**COMMENTS BY THE TEXAS COMMISSION ON ENVIRONMENTAL QUALITY AND THE
PUBLIC UTILITY COMMISSION OF TEXAS REGARDING THE PROPOSED STATE OF
TEXAS REGIONAL HAZE AND INTERSTATE VISIBILITY TRANSPORT FEDERAL
IMPLEMENTATION PLAN**

DOCKET ID NO. EPA-R06-OAR-2016-0611

Figure 1: EPA SO₂ Emission Trend Data for Milton R. Young Unit 1 (Source: Docket ID No. EPA-R06-OAR-2016-0611-0008, TX187-0008-0033-BOD-Selected BOD SO₂ Averages-3)

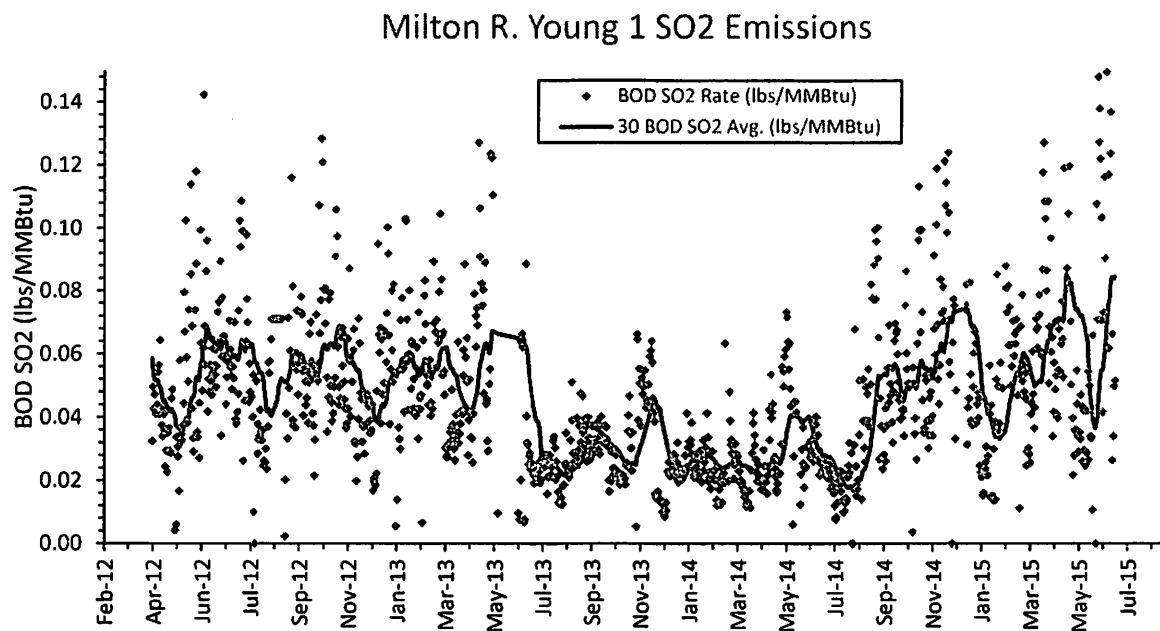
EPA Region 6 has not justified why its proposed BART determinations for SO₂ control on coal-fired EGUs in Texas are inconsistent with other EPA BART determinations. The proposed SO₂ limit for retrofit wet scrubbers on lignite-fired units is not supported by the EPA's own data provided with the proposed FIP. The EPA should not arbitrarily assume that wet FGD scrubbers on lignite-fired units can achieve the same level of SO₂ emission rate on a lb/MMBtu basis as low-sulfur PRB subbituminous coal-fired units.

Figure 2: EPA SO₂ Emission Trend Data for Jeffrey Energy Center Unit 3 (Source: Docket ID No. EPA-R06-OAR-2016-0611-0008, TX187-0008-0033-BOD-Selected BOD SO₂ Averages-3)

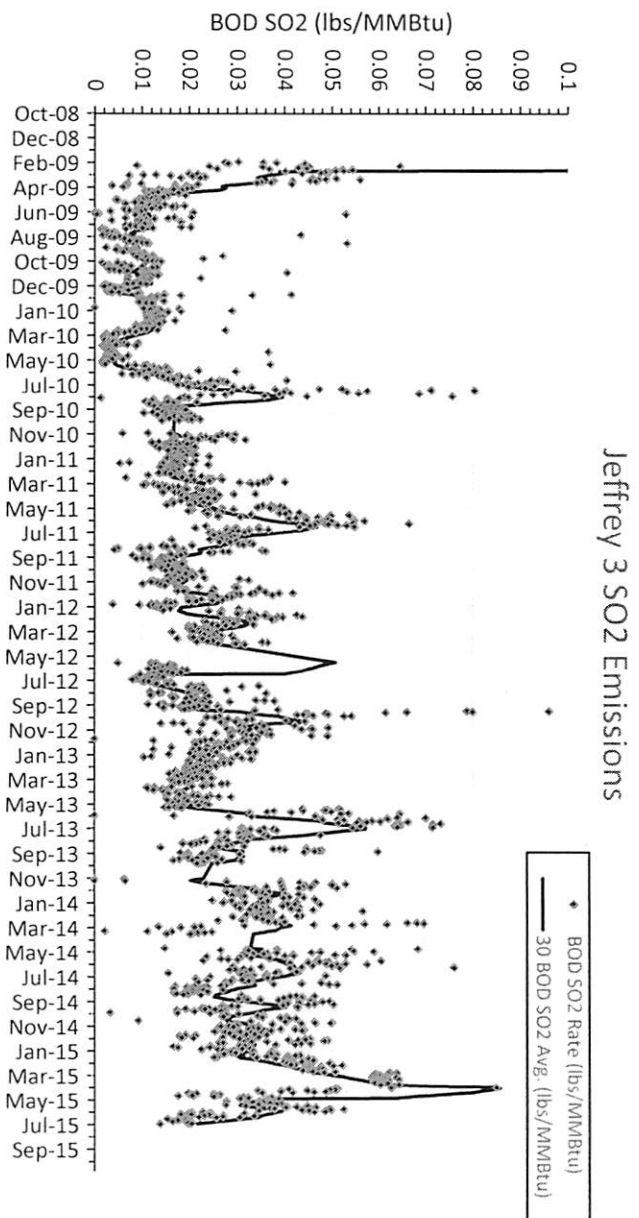
The EPA's proposed emission standards apply at all times, including startup and shutdown operations. However, the EPA has not given proper consideration to emission spikes that can occur during startup operations that can cause a significant spike in even a 30-boiler operating day average until the startup day rolls out of the 30-day average. The EPA's own emissions trend data provided in the technical support documents demonstrates that such spikes would represent a compliance problem for some of the units that the EPA evaluated in establishing the proposed BART emission standards. Figures 2 and 3 provide examples from the EPA's technical support document with selected 30-boiler operating day average data (Docket ID No. EPA-R06-OAR-2016-0611-0008, TX187-0008-0033-BOD-Selected BOD SO₂ Averages-3) for two units with wet FGD. While all the spikes in the SO₂ emissions trend for Jeffrey Energy Center Unit 3 and James H. Miller Unit 4 may not necessarily be associated with startup operations, the EPA's data demonstrates the significant variation that can occur in SO₂ emission rates even when using a 30-boiler operating day average which the EPA has not accounted for in selecting the proposed emission limits for retrofit scrubbers.

Figure 4: Coal-fired EGU Age Profile (United States Department of Energy, EIA, 2015 Form EIA-860 data).

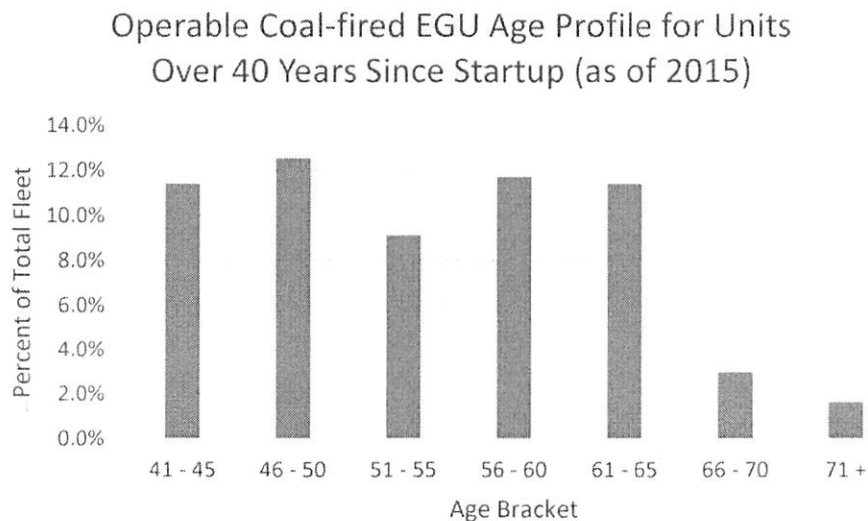
While coal-fired EGUs can remain operational for 60 - 70 years and the affected BART units could theoretically last another 30 years, the EPA's selection of 30 years for the remaining useful life of these units is arbitrary and does not take into consideration the current state of the energy sector and many other factors that will affect how long these units will continue to remain operational. The age of the coal-fired EGUs subject to the EPA's proposed FIP range from 35 to 46 years, which the average being approximately 40 years. EPA's assumed 30 years of remaining useful life assumes these units will remain operational until they are 65 to 76 years old. However, this assumption does not reflect actual operational life data from the United States Department of Energy, Energy Information Administration (EIA). Figure 4 presents the age brackets for operable coal-fired EGUs with over 40 years of operation, based on EIA's 2015 Form EIA-860 data. Less than 5% of the operable fleet in 2015 was greater than 65 years in age.

For units in EIA's 2015 Form EIA-860 data with expected retirement dates, the average expected age at retirement is only 53 years and the median age is 57 years. Based on just the current age profile of the units affected by the EPA's proposed FIP and the EIA information from Form EIA-860, the expected remaining useful life of these units is more likely between 10 - 20 years, not the 30 years assumed by the EPA. Other factors, such as the current energy sector market pressure and other regulatory impacts, could shorten the remaining useful life even further.

Figure 5: Cost Effectiveness Comparison for Welsh #1

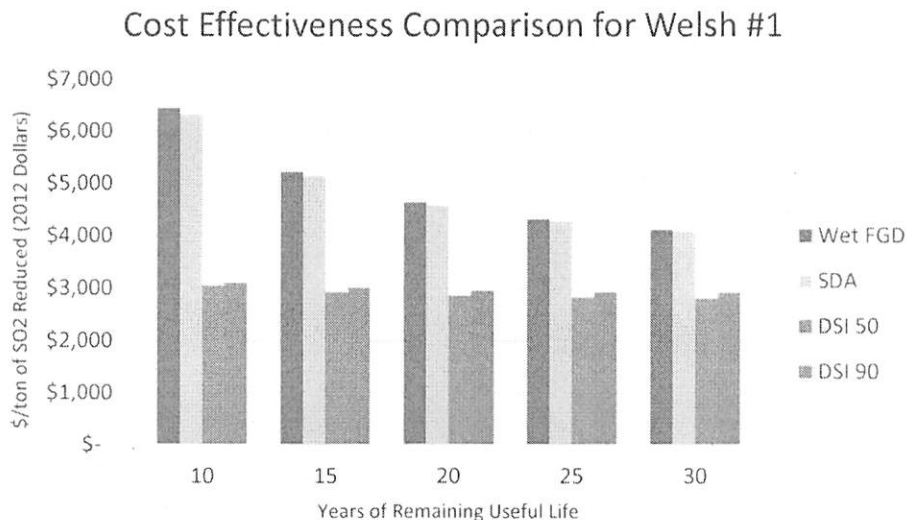
Furthermore, the EPA's cost effectiveness calculations of some of the technologies evaluated by the EPA are significantly biased as a result of using a 30-year time for annualizing capital costs. While the cost effectiveness of DSI remains relatively flat over different time periods for remaining useful life due to its relatively low capital costs, cost effectiveness estimates for wet FGD and SDA are significantly impacted by the time period assumed for remaining useful life due to the far higher capital costs associated with those technologies. Figure 5 illustrates the impact of remaining useful life assumed when calculating cost effectiveness on the same technologies evaluated by the EPA using the EPA's same cost estimates. The EPA's cost effectiveness estimates for wet FGD and SDA are severely underestimated as a result of the EPA's artificially high remaining useful life estimate.

Figure 6: Comparison of Natural Conditions Estimates

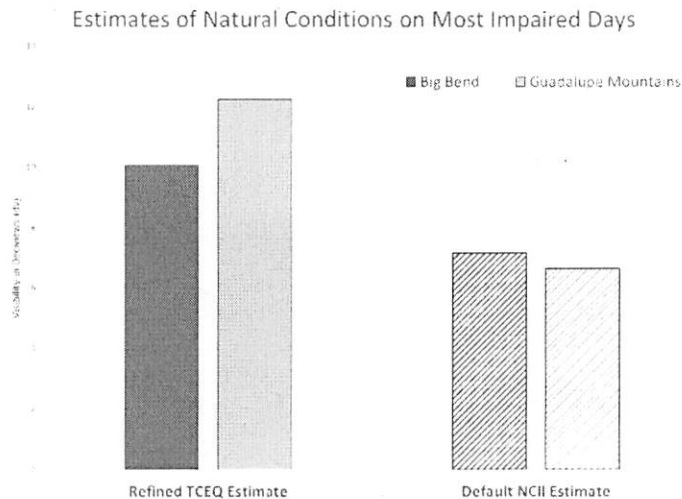
Specifically, Class I areas located in West Texas are heavily impacted by large dust storms and windblown dust from the surrounding highly erodible soils. These dust events should be considered when estimating the natural conditions for Class I areas in Texas. As shown in the figure below, the result of including this site-specific information is that the more

representative estimates of natural conditions calculated by the TCEQ are higher than the default NCII values used by the EPA.
